PIERCE COUNTY TERMINAL WHARF AND PHASE 2 DREDGING AND SLIP 5 MITIGATION CONTRACT NO. 998149

RECORD DRAWINGS

THESE RECORD DRAWINGS HAVE BEEN PREPARED BY ENGINEERING CONSULTANTS BASED UPON MARKUPS AND INFORMATION FURNISHED BY MANSON/TRAYLOR JV. WHILE THIS INFORMATION IS BELIEVED TO BE RELIABLE, THE CONSULTANTS CANNOT ASSURE ITS ACCURACY, AND THUS IS NOT RESPONSIBLE FOR THE ACCURACY OF THESE RECORD DRAWINGS OR FOR ANY ERRORS OR OMISSIONS WHICH MAY HAVE BEEN INCORPORATED INTO IT AS A RESULT. THOSE RELYING ON THESE RECORD DRAWINGS ARE ADVISED TO OBTAIN INDEPENDENT VERIFICATION ON THEIR ACCURACY BEFORE APPLYING IT FOR ANY PURPOSE. INFORMATION THAT IS CLOUDED REPRESENTS CHANGES MADE TO THE DESIGN DRAWINGS.

PILE AND PILE CAP PLAN

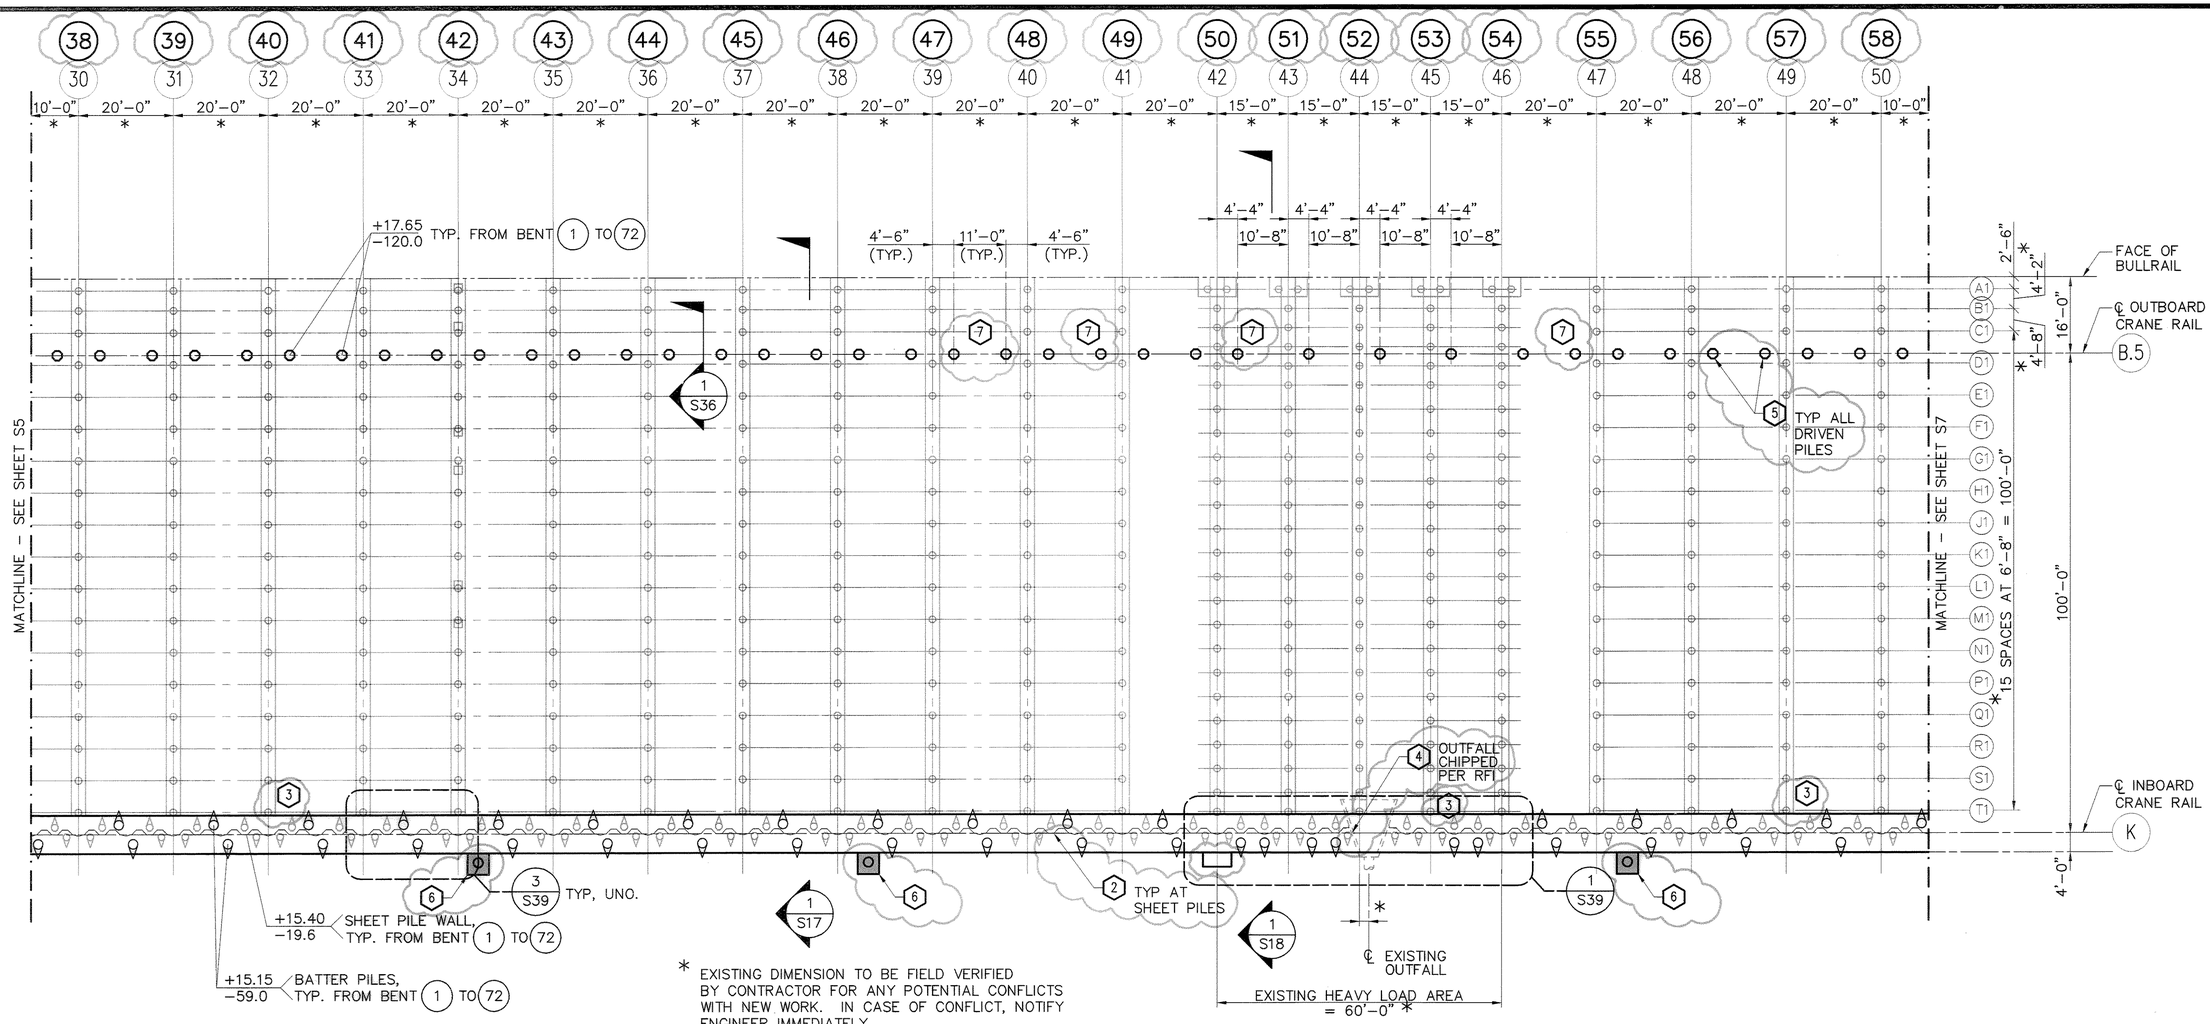
(5) NOTE AS–BUILT PILE LOCATIONS, SEE BACK OF DRAWING S5. (PILE NUMBERING IS REFERENCED FROM DRAWING S9.1)

SHEET 44 OF 164

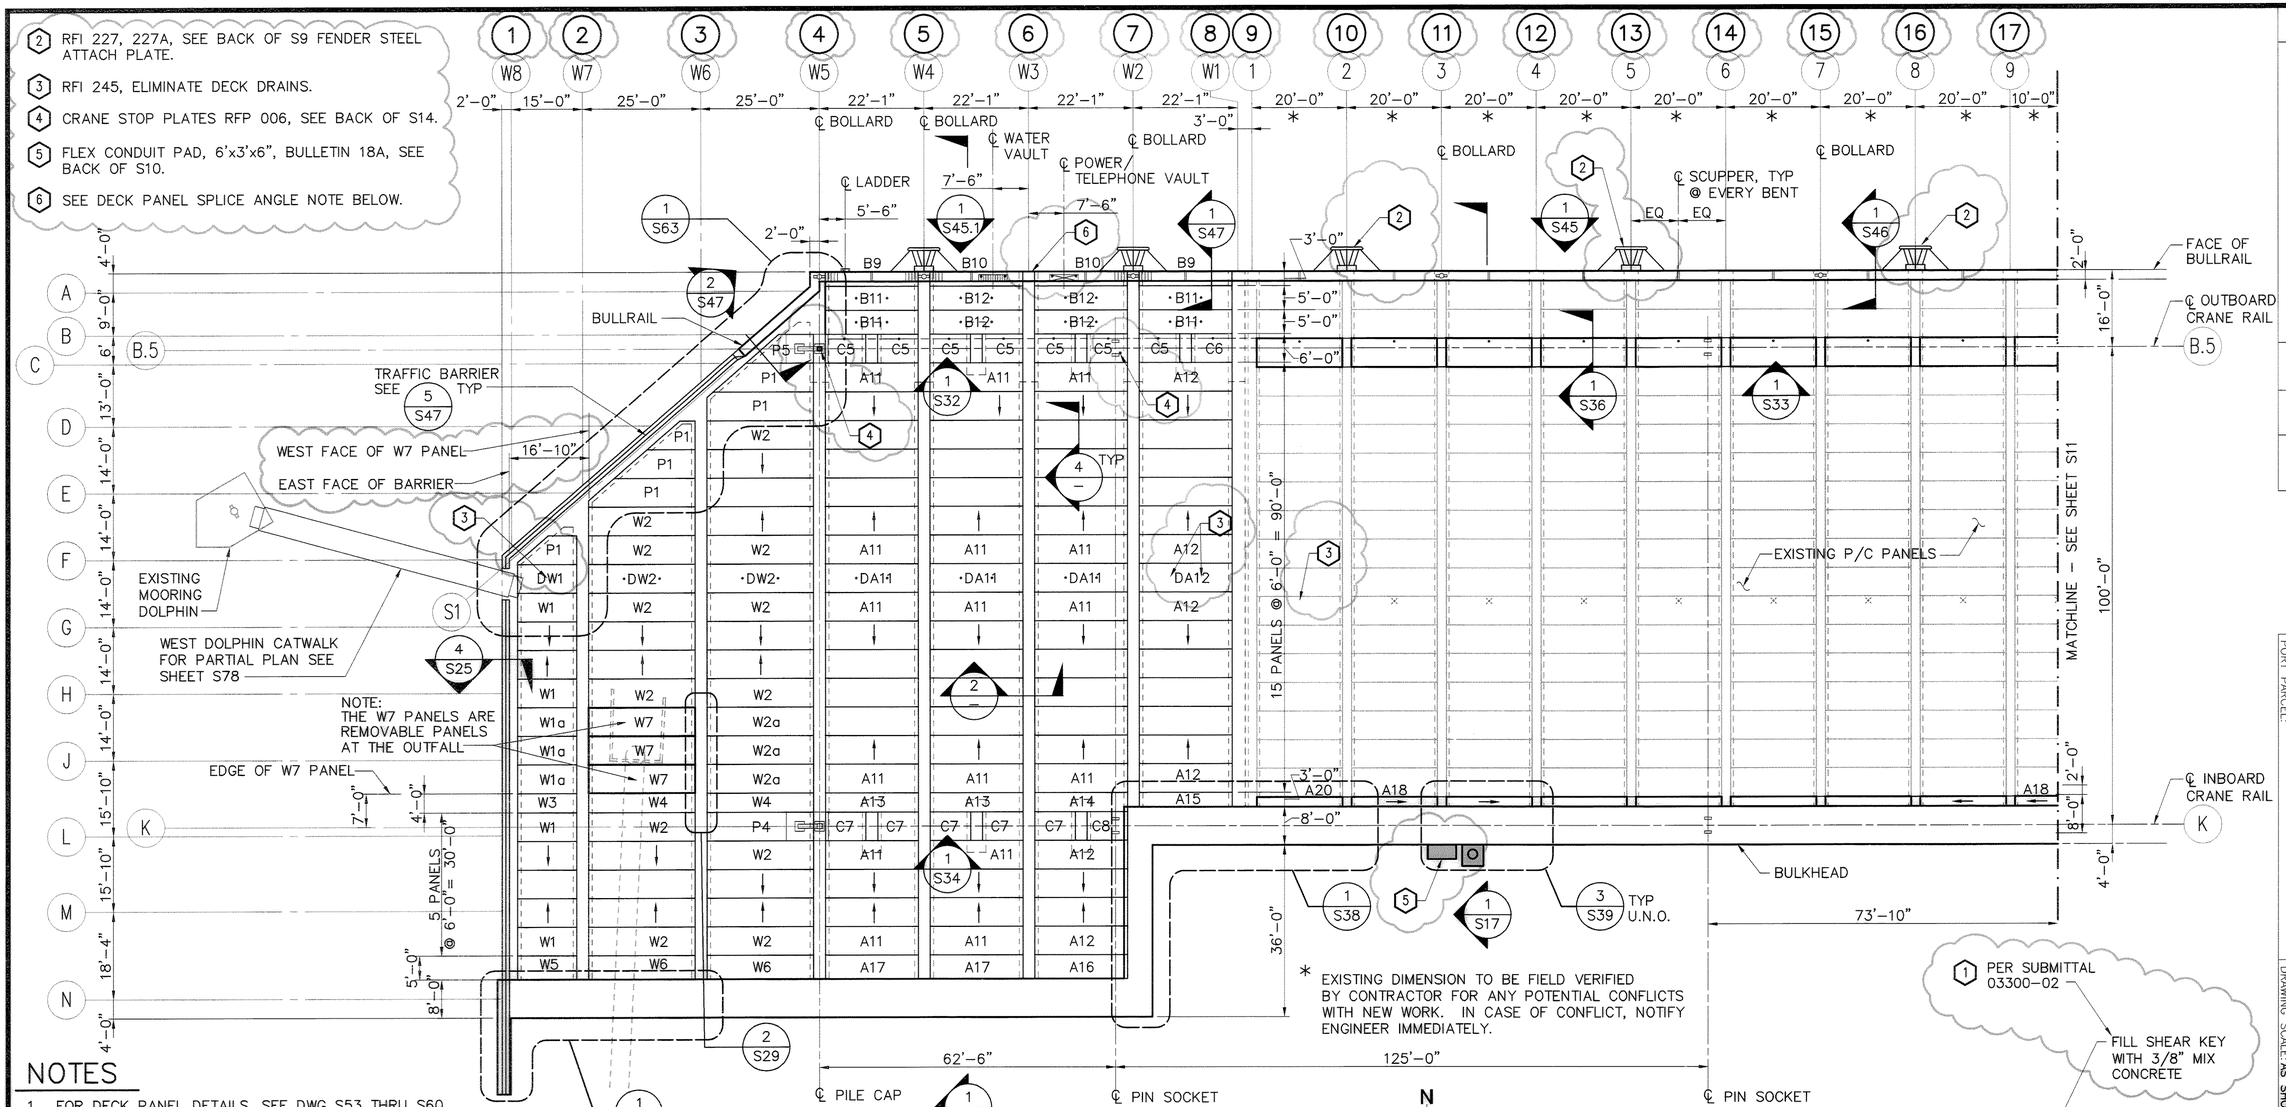
(2) RFI 227, 227A, SEE BACK OF S9 FENDER STEEL ATTACH PLATE.

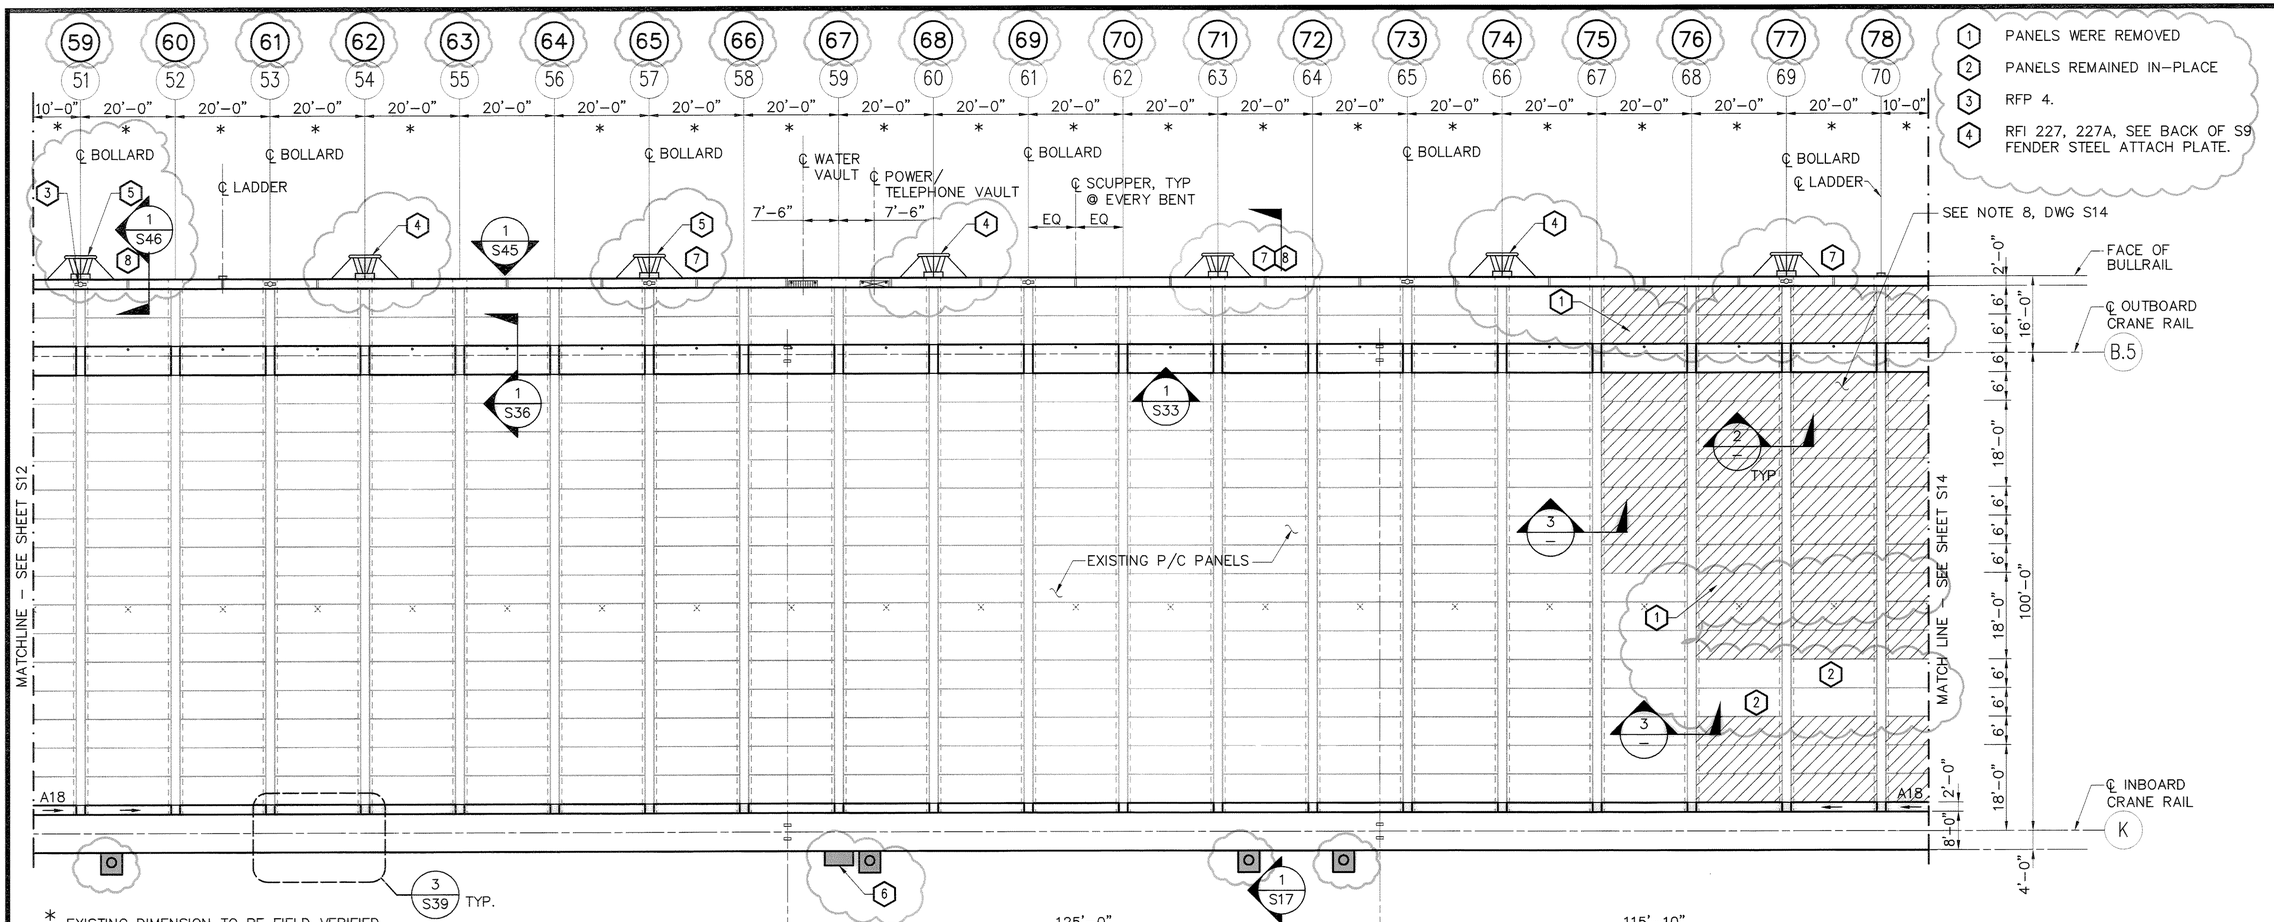
1. PANELS WERE REMOVED
2. PANELS REMAINED IN–PLACE
3. RFP 4.
4. RFI 227, 227A, SEE BACK OF S9 FENDER STEEL ATTACH PLATE.

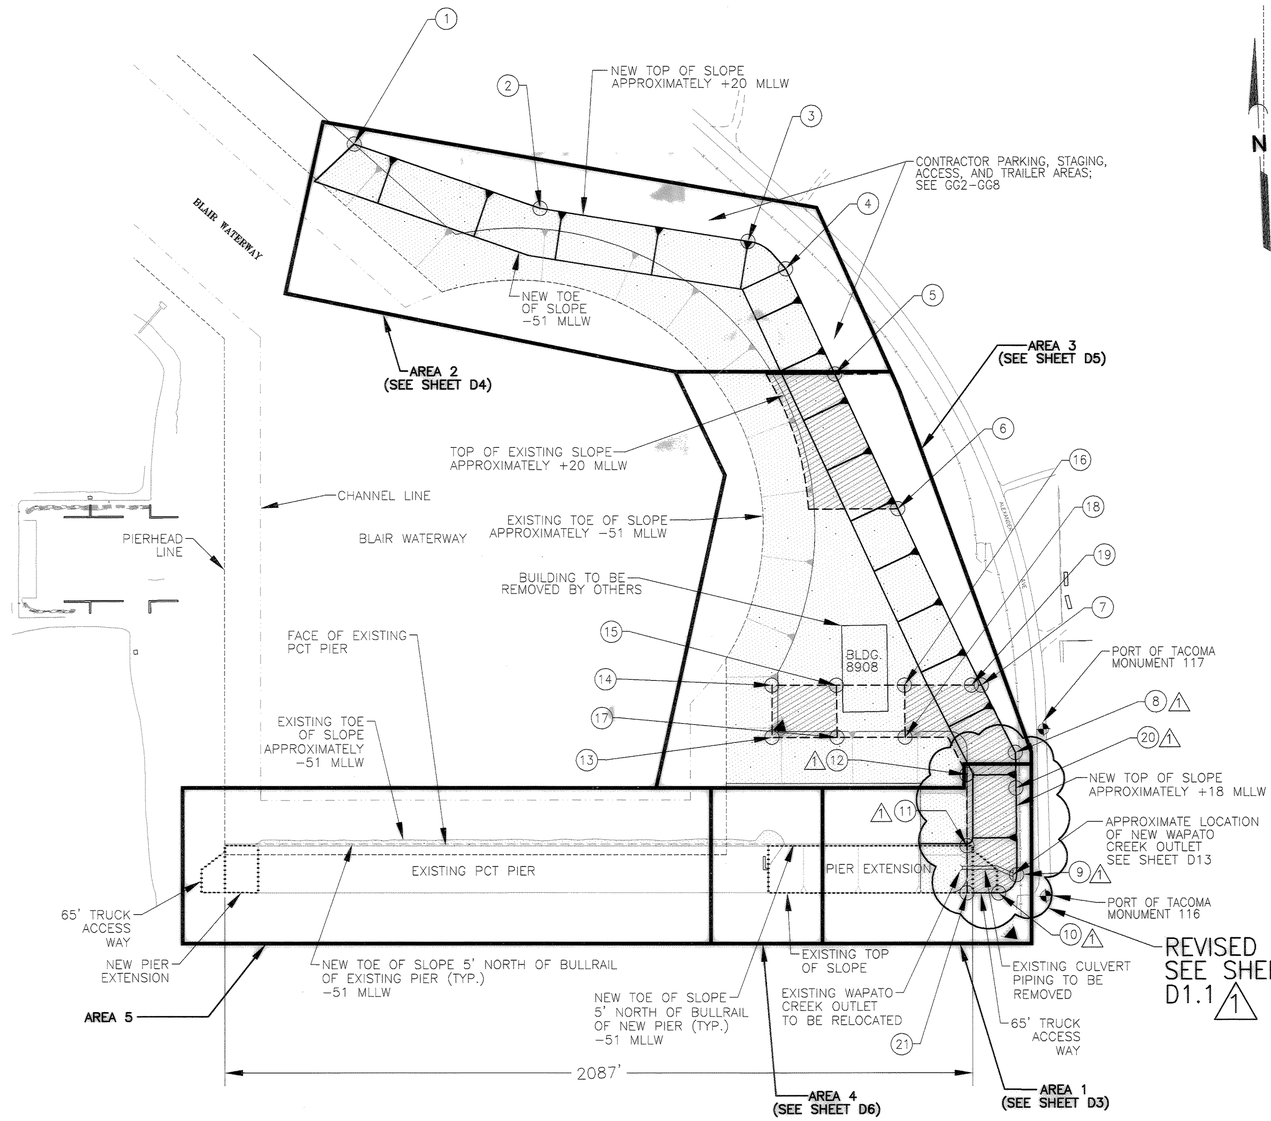
1 TOP OF SLOPE MOVED EAST PER RFI 63. SEE "AS-CONSTRUCTED" CONDITIONS ON SHEET D1.1.
